HISTORIC AND DESIGN REVIEW COMPLIANCE AND TECHNICAL ADVISORY BOARD

HDRC CASE NO: 2024-152
ADDRESS: 250 QUENTIN DR
LEGAL DESCRIPTION: NCB 6708 BLK 18 LOT 21
ZONING: R-6, H
CITY COUNCIL DIST.: 7
DISTRICT: Monticello Park Historic District
APPLICANT: Maziyar Entezami/ENTEZAMI MAZIYAR
OWNER: Maziyar Entezami/ENTEZAMI MAZIYAR
TYPE OF WORK: Roof reconstruction and modifications, exterior modifications, fencing
APPLICATION RECEIVED: March 29, 2024
60-DAY REVIEW: May 28, 2024
CASE MANAGER: Edward Hall

Historic and Design Review Commission
Design Review Committee Report

HDRC Case #: 2024-152

EXISTING/PROPOSED ELEVATION
SCALE: 1/4" = 1'-0"

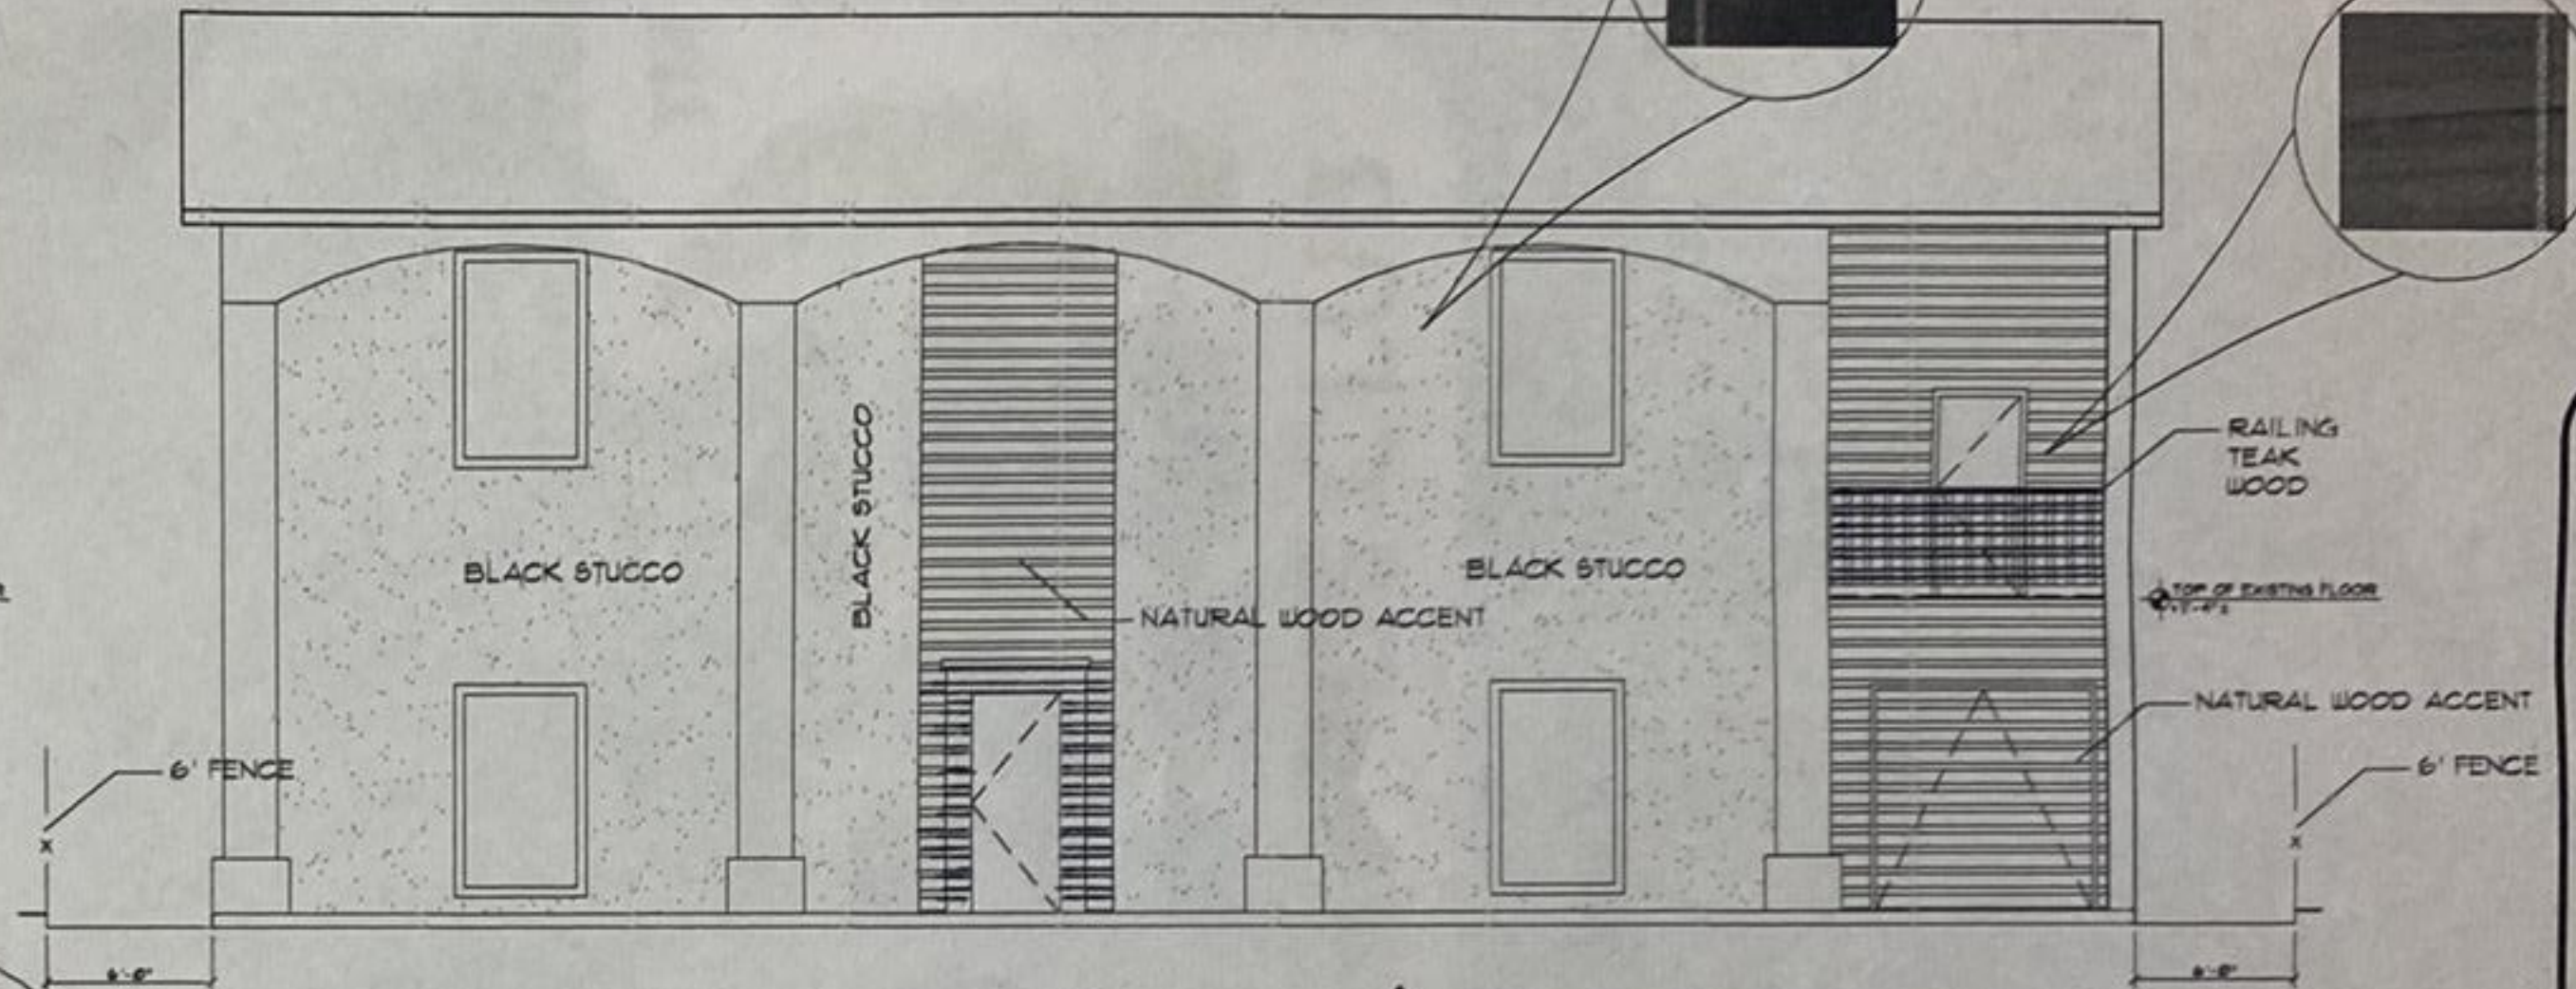
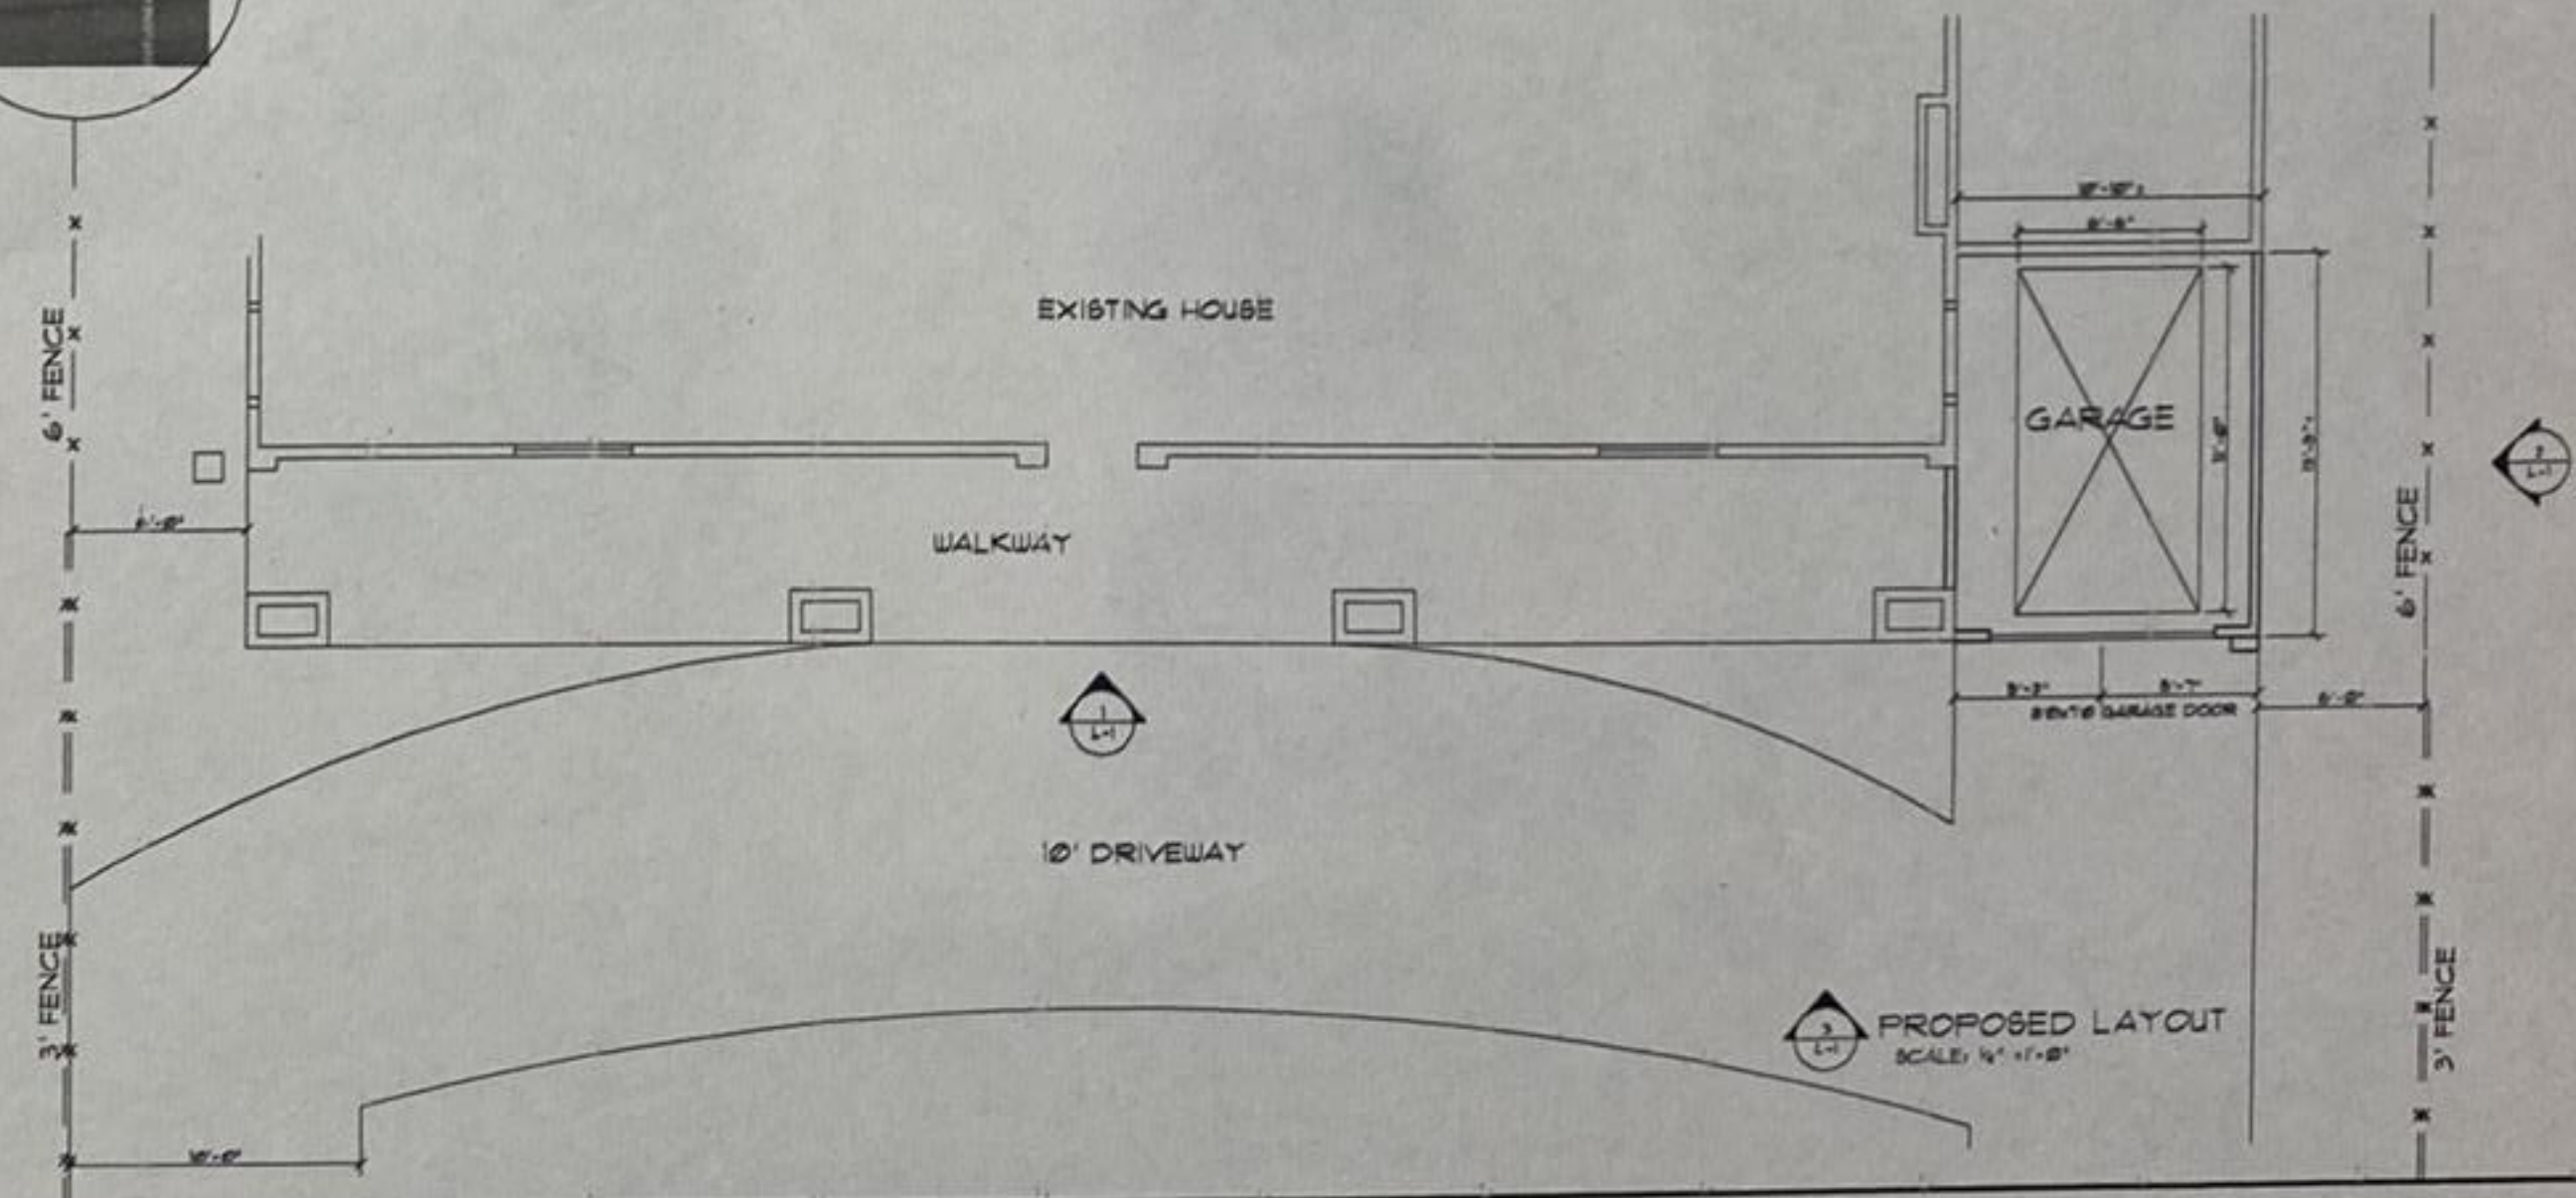
ME: Reconstructed ridge height matches 236 Quentin

ME: Overview of increase in height of ridge height.

JV: Why the increased height? ME: Per code, two, 5 ton HVAC units are required and 2 water tank heaters will be stored in the attic.

JV & MS: Reconstructed roof is not appropriate and not in context with the existing examples within the district.

MS: By listening to the conversation at the hearing and by looking at previous photos, the roof as reconstructed is not appropriate. An alternative solution with a reduced ridge height should be considered. Additional comments on solutions that could be explored...lower plate heights, dormers, etc.

JV: Ridge height should be decreased.

MS: Goal should be to return the house to its original massing.

1. Staff recommends approval of item #1, the reconstruction of the roof structure with the following stipulations:
 - i. That the side addition should maintain a subordinate ridge height, as was previously constructed.
